NORTH CENTRAL STATE AIRPORT  
 WILDLIFE FENCE INSTALLATION AND REPAIR  
**WETLAND IMPACTS**  
**SHEET 1 OF 16**

DEPARTMENT OF ENVIRONMENTAL MANAGEMENT  
 OFFICE OF WATER RESOURCES  
 FRESHWATER WETLANDS PROGRAM  
 APPROVED WITH CONDITIONS  
 AS SPECIFIED IN THE LETTER OF APPROVAL  
 DATED **JUL 30 2021** FILE # **21-0204**  
 NO CHANGES ALLOWED WITHOUT PRIOR APPROVAL  
 APPROVED PLANS MUST BE AT CONSTRUCTION SITE

PROJ. No.: 301012  
FILE: SFZ-PS203  
AIP No.: 3-44-0004-XXX-2021  
DRAWING NO.  
**PS2.9**  
SHEET 10 OF 20

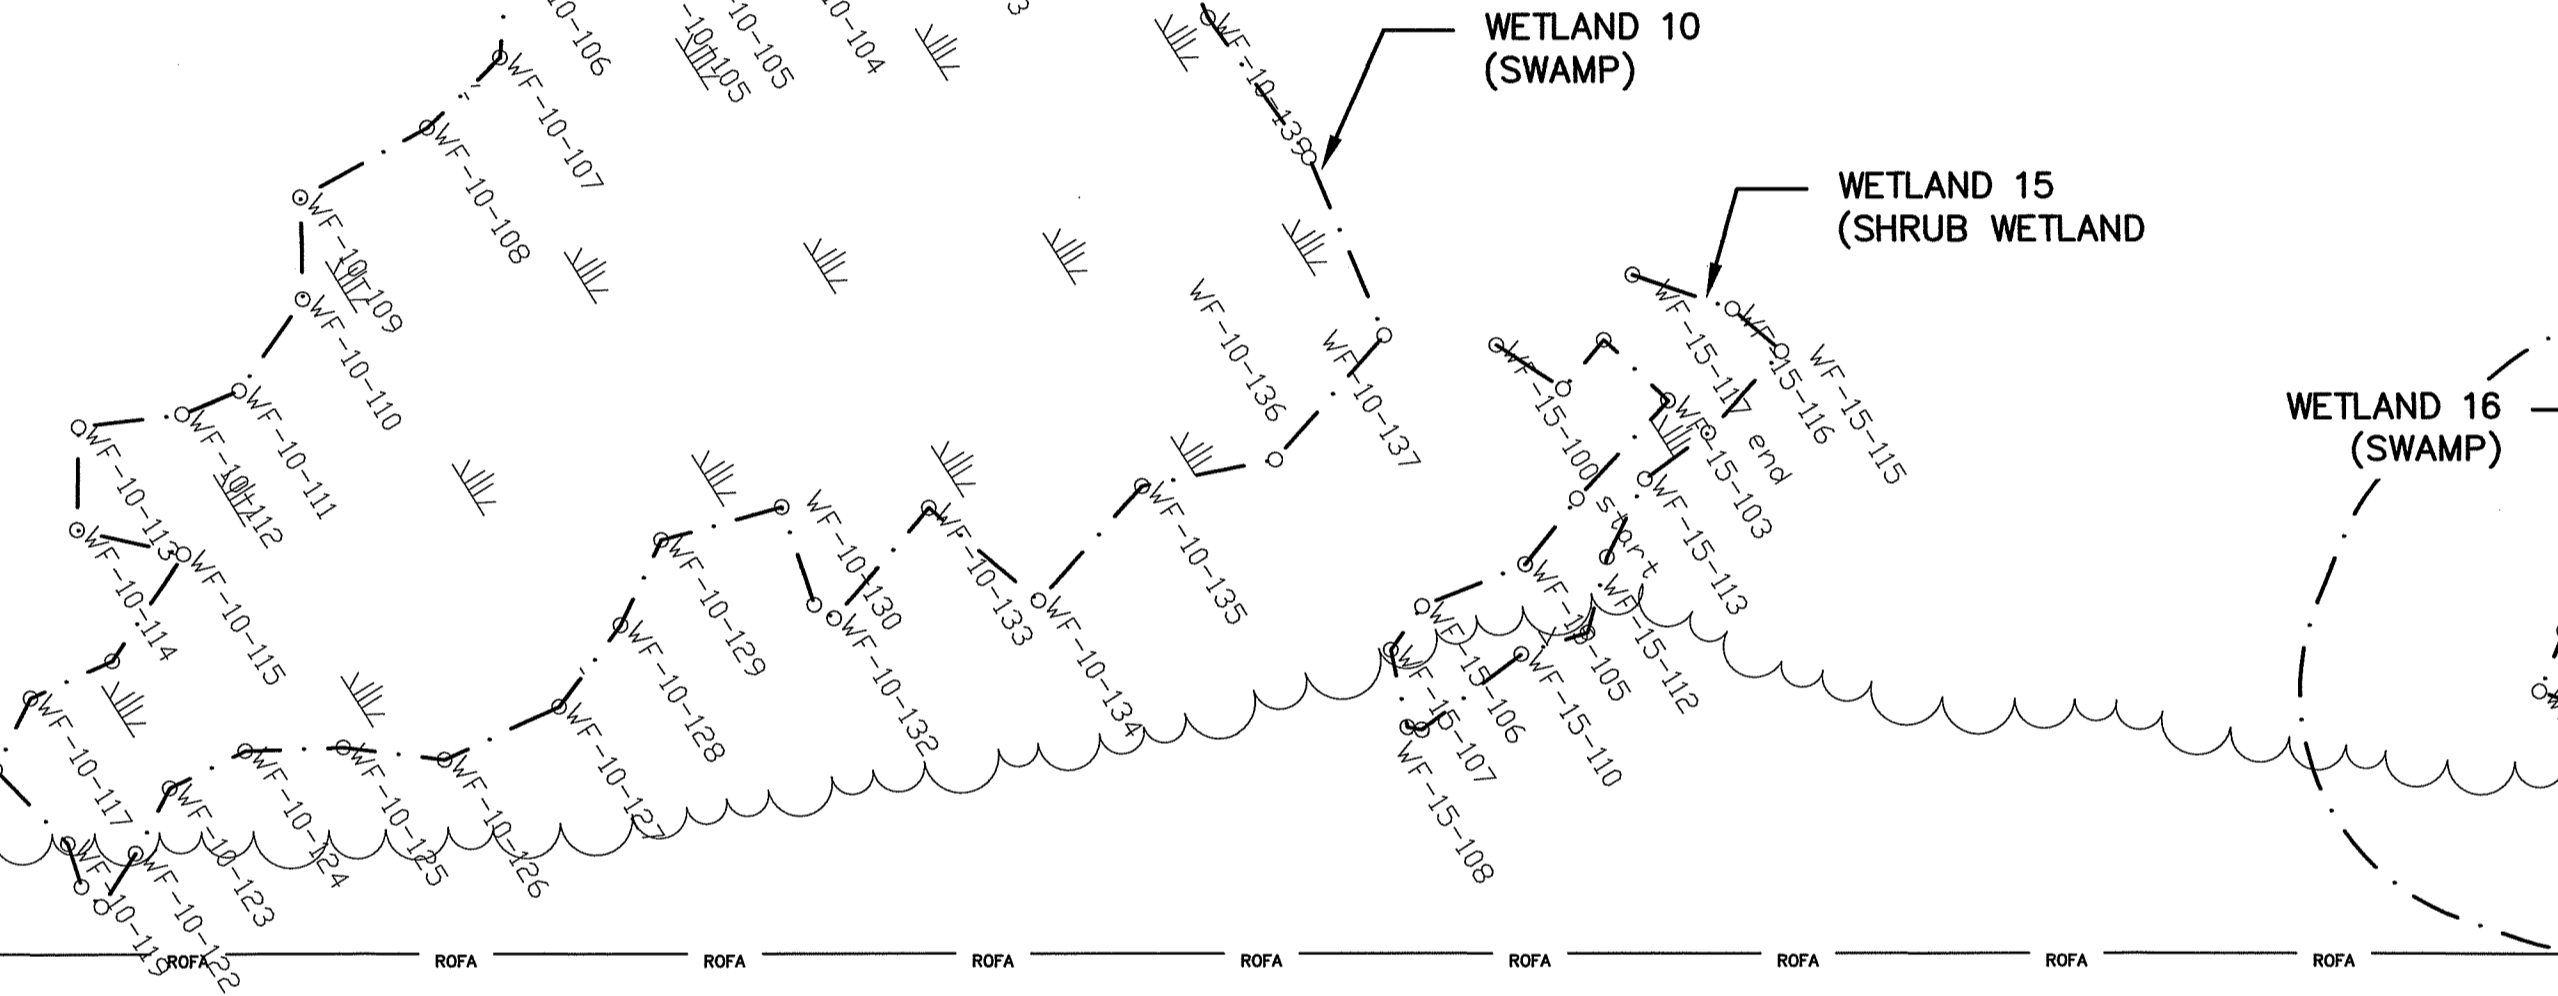
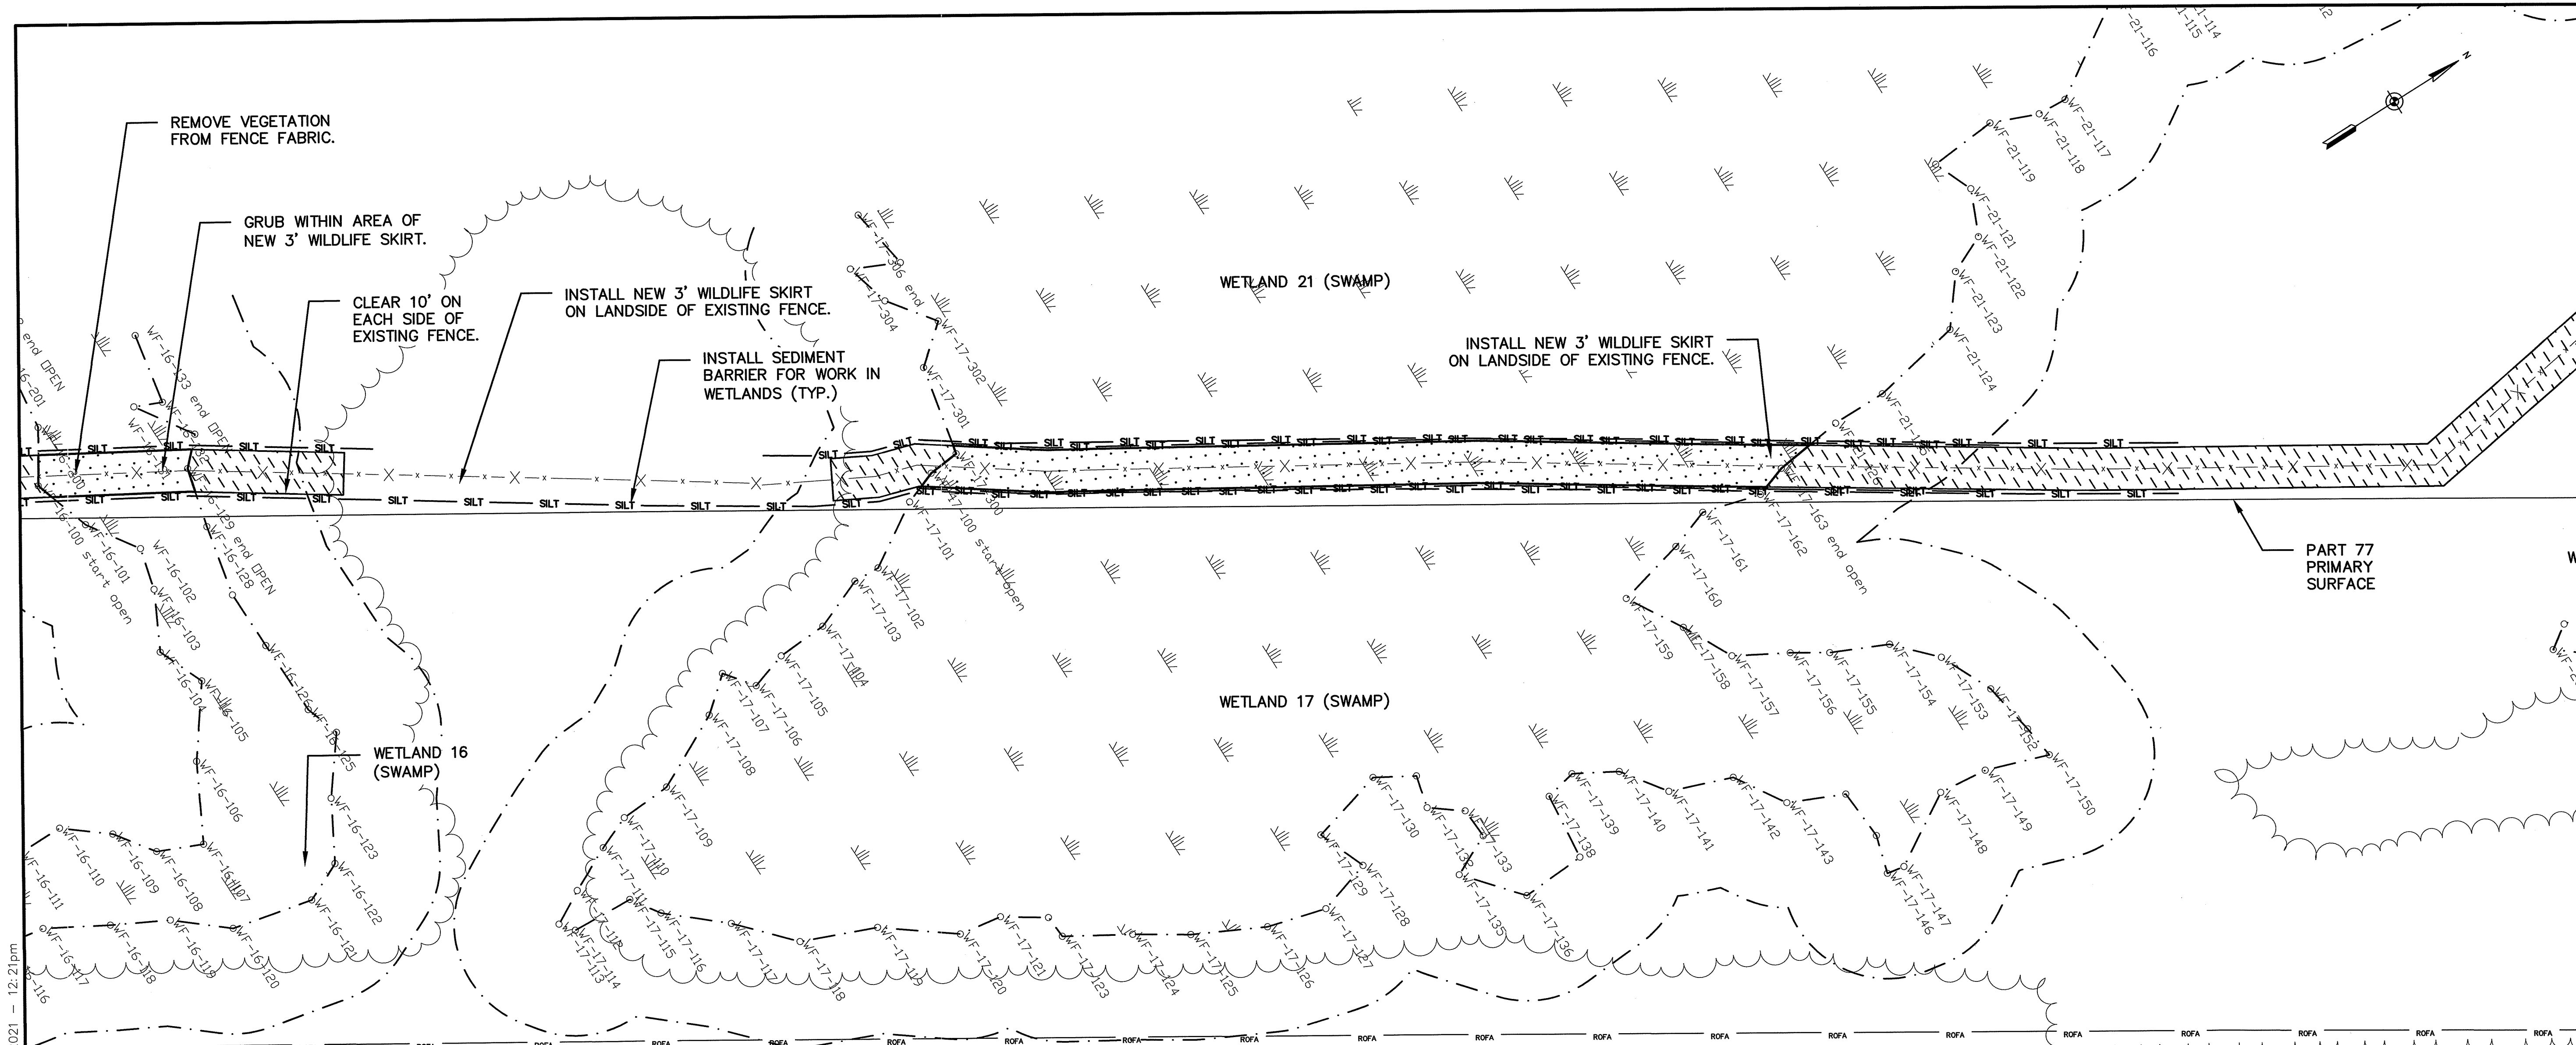
Note per DEM: Extend silt fence
